SERVICE BULLETIN

No: AG022 - 15 Rev 4

Subject:	L40, M59, L45 4WD PROPELLER SHAFT >>MANDATORY FIELD CAMPAIGN<<	
Model(s):	L3240HSTCC3, L3240HST-3, L3240DT-3, L3540HSTCC3, L3540HST-3, L3540GST-3, L3940HSTCC3, L3940HST-3, L3940DT-3, L4240HSTCC3, L4240HST-3, L4240GST-3, L4740HSTCC3, L4740HST-3, L5040GST-3, L5240HSTCC3, L5240HST3, L5740HSTCC3, L5740HST3, M59, L45TLB (HST)	
Serial Ranges:	GL40, M59, L45	See below/ voir ci-dessous

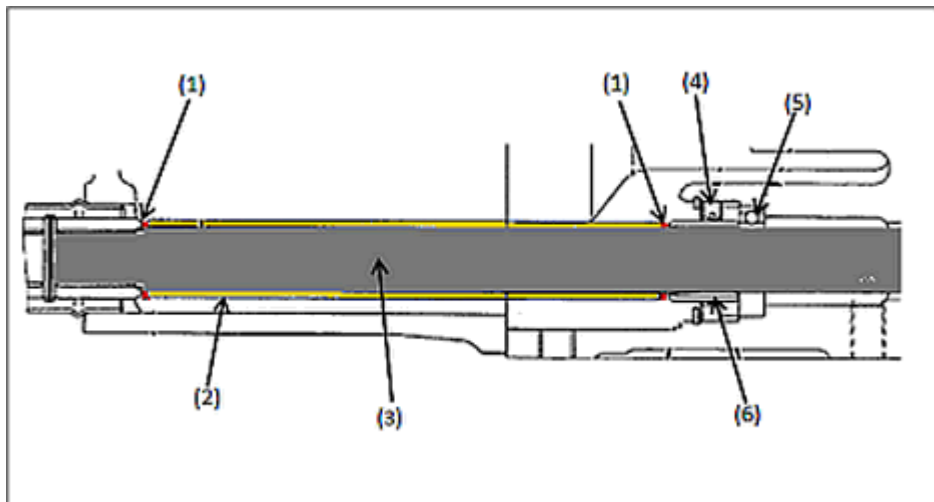
Kubota has found that the 4WD propeller output shaft oil seal(4) may leak without the use of an output shaft spacer(2). This campaign is to prevent a transmission oil leak between the shaft oil seal(4) and sleeve(6) by installing a spacer(2) and o-rings(1) to prevent displacement of the shaft sleeve(6).

Sept 28, 2015 UPDATE: If the output shaft seal is found to be leaking when the spacer is being installed a separate warranty claim may be submitted. See "Allowable Labour Update # 3" below.
